Modification Recommended Service Note

Supersedes:
MSOS404A-03D

MSOS404A – MSO Infiniium S Series 4GHz 4 channel

The Problem – Under certain circumstances a PLL2 error may occur on the S-series products.

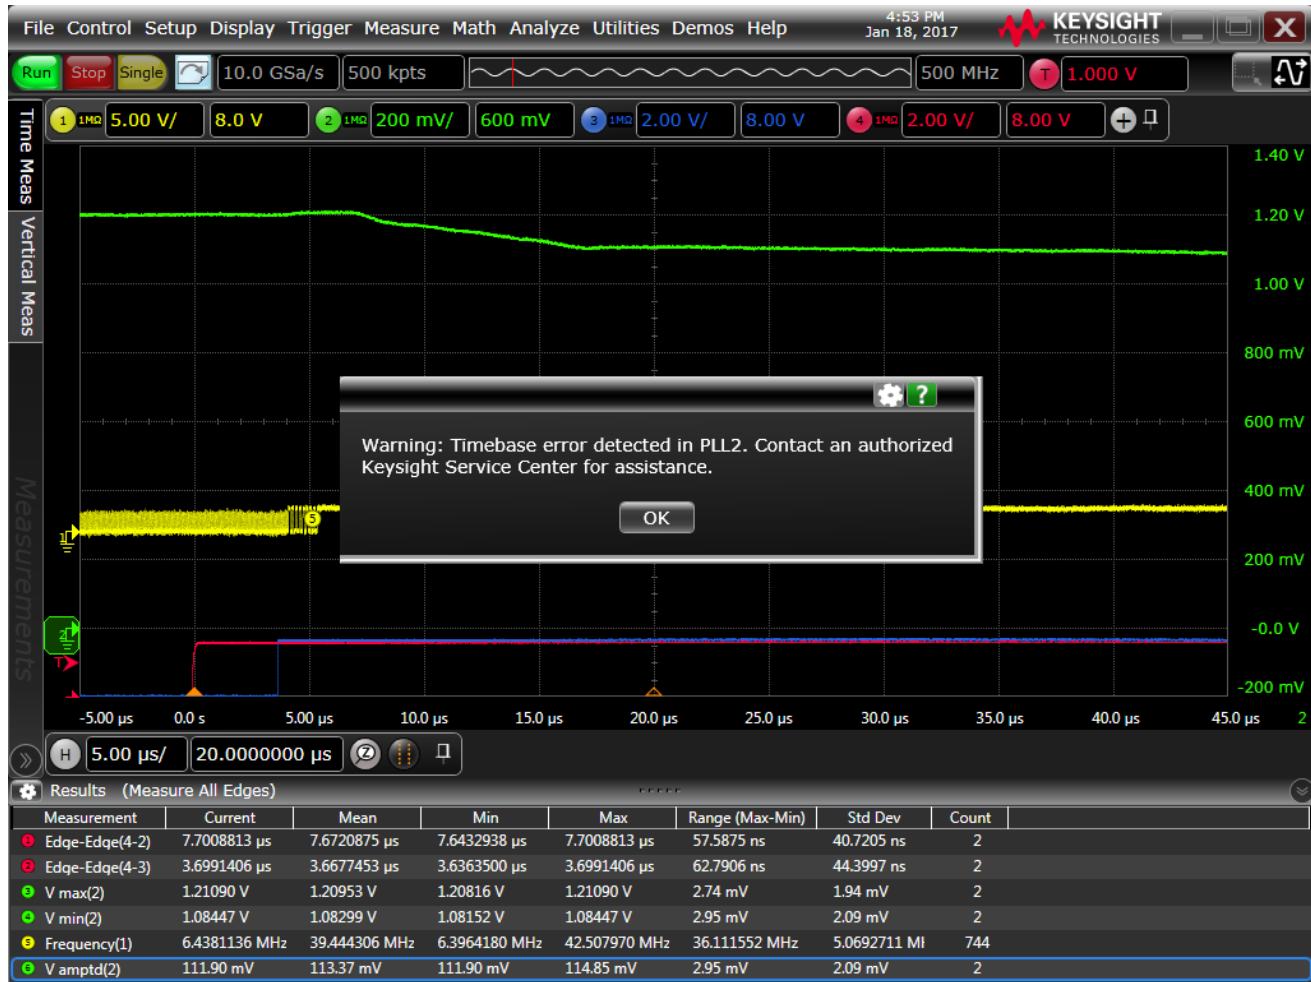
On older acquisition boards a PLL2 error message sometimes occurs. The error message appears on the screen as below:

There are new acquisition boards that fix this issue for the S-series scopes.

Please, use the 54911-69511 board until is gone.

If you have a 54911-69511, then skip steps 1 and 2 and proceed to step 3.

If there are no 54911-69511, then start with step 1 below.

1. If the customer needs to have software revision < 6.10.01001, then replace the acquisition board with the 54911-69532 board.
2. If the customer can have software revision \geq 6.10.01001, then it can be replaced by any of these three boards: 54911-69521, 54911-69531, or 54911-69532.
